IMPORTANT NOTICE

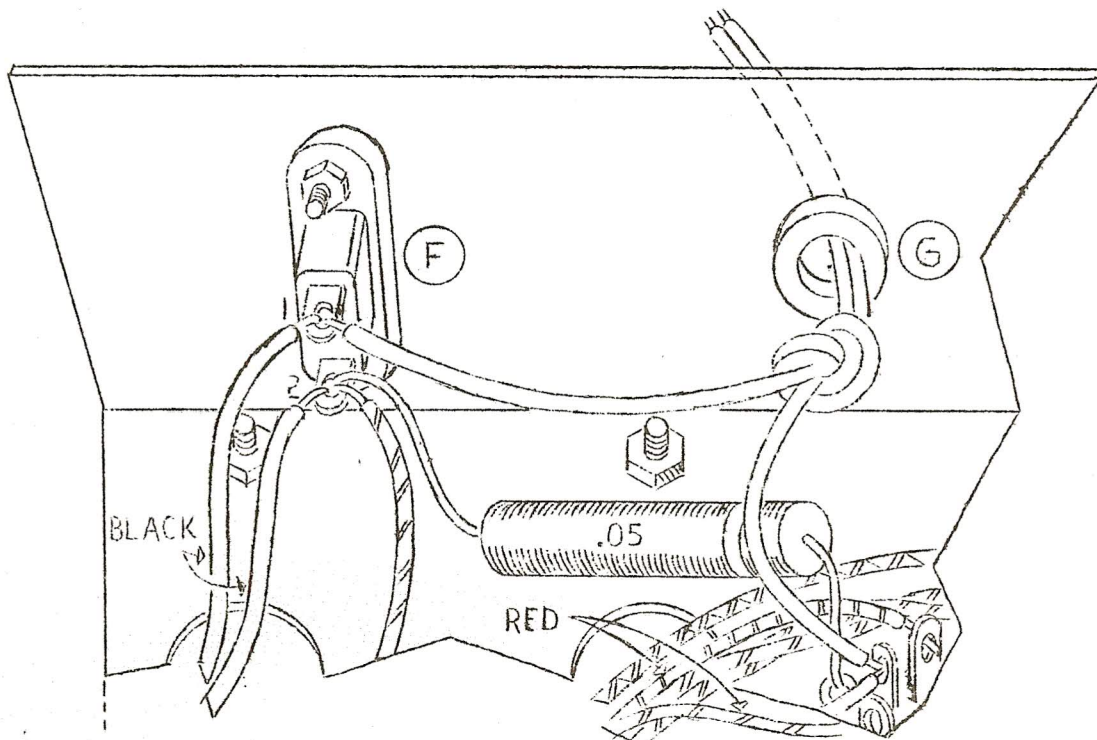
Pictorial 3 in the manual and large insert sheet is in error. The line cord should be connected to tube socket D5 and to 110 volt socket F1 instead of D5 and F2 as originally shown. The correct wiring at this point is shown below.

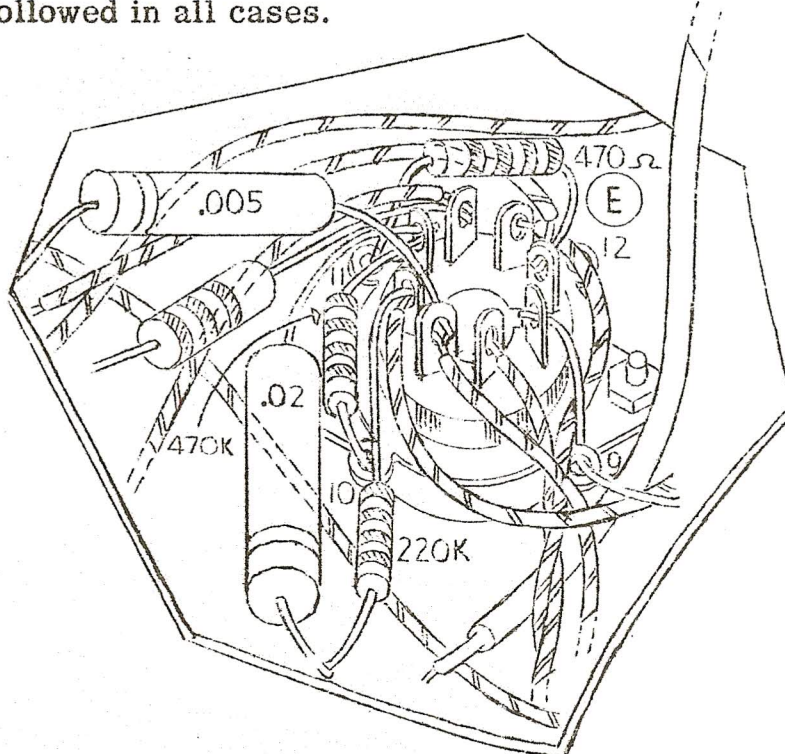
At tube socket E, a 470K resistor is shown connected between socket ground lugs E10 and E11. The resistor should be connected between E10 and E5 as shown below. The step-by-step procedure and schematic are correct and should be followed in all cases.
